# Historic Preservation Commission

## Staff Report

**Case #:** HPC-47-22

**Site Address:** 1603 Dearing Place  
**Parcel ID:** 31-06-23-3-022-014.000  
**Applicant:** Steve Mouzon  
**Owner:** Tim Leopard

EXISTING FRONT ELEVATION

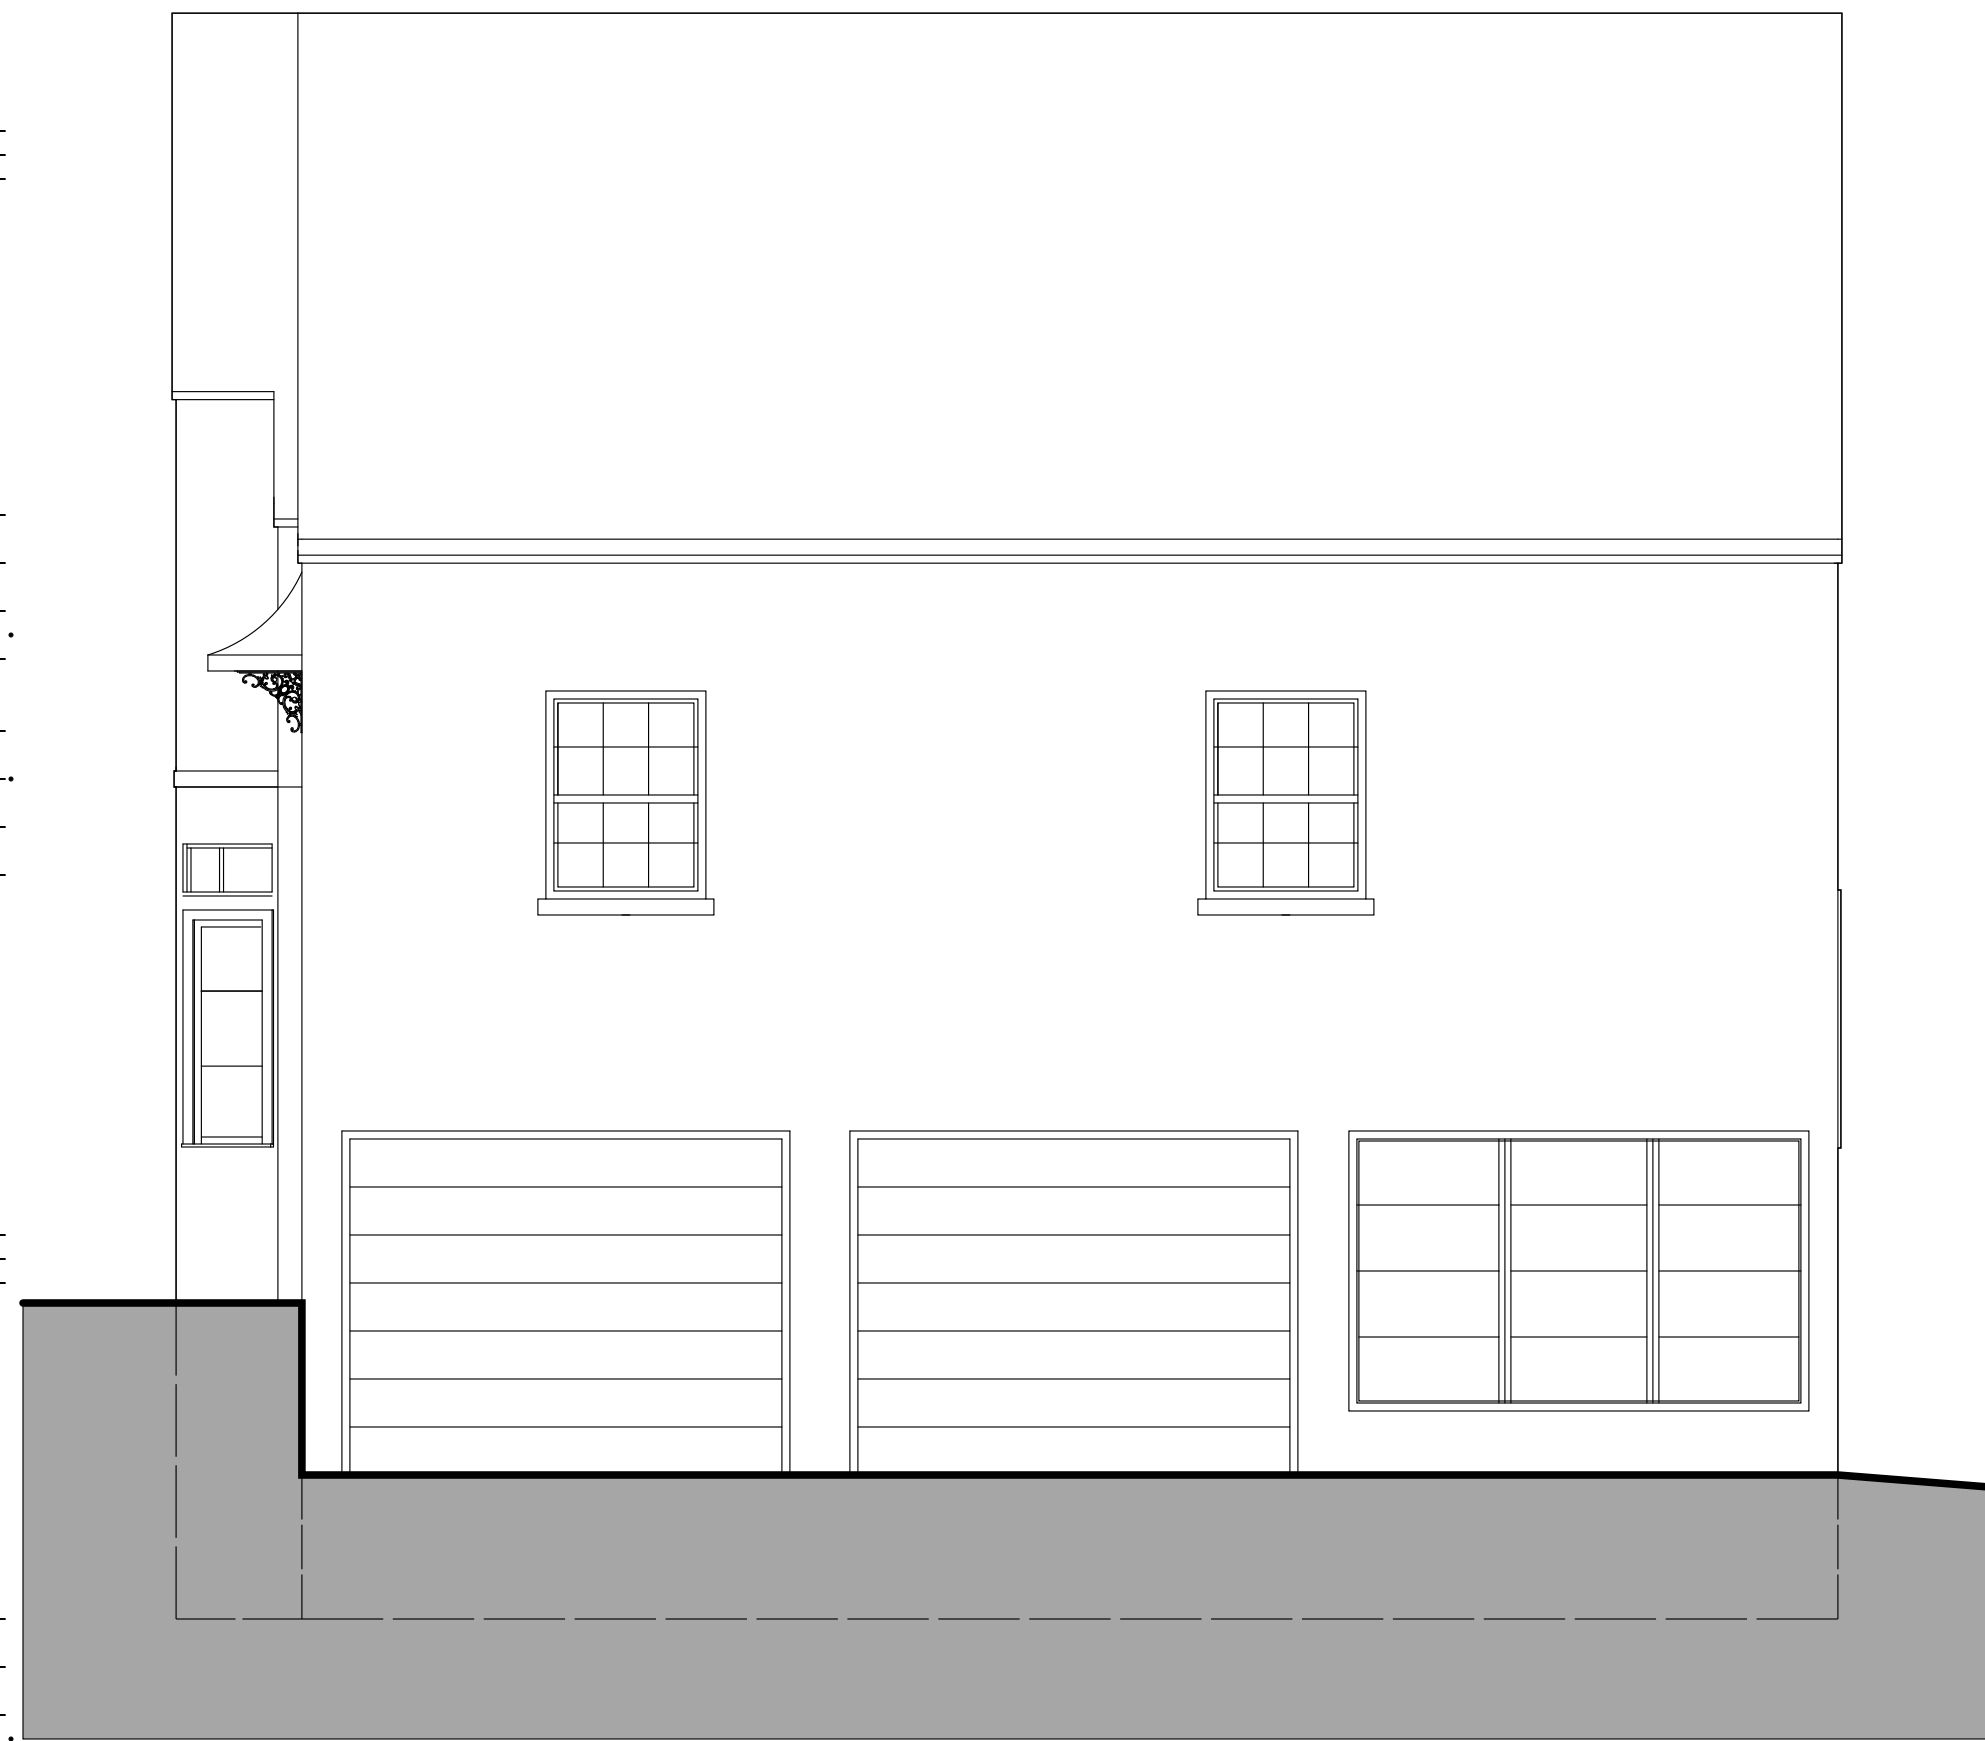
**Roofs:** The roof style on the proposed dormer on the right elevation is not consistent with the other dormer roofing styles. The awning on the front elevation is proposed to change from architectural shingles to standing seam copper, which is an appropriate awning material (DG 30).

**Windows:** Some windows will be adjusted to be centered with the exterior of the house, and there will be new windows added to replace the attic vents. There are many different window designs on the existing house, and the applicant is proposing to replace the windows with aluminum-clad wood casement windows with a consistent 2x3 design on all windows. The proposed windows meet the guidelines in material and design (DG 31).
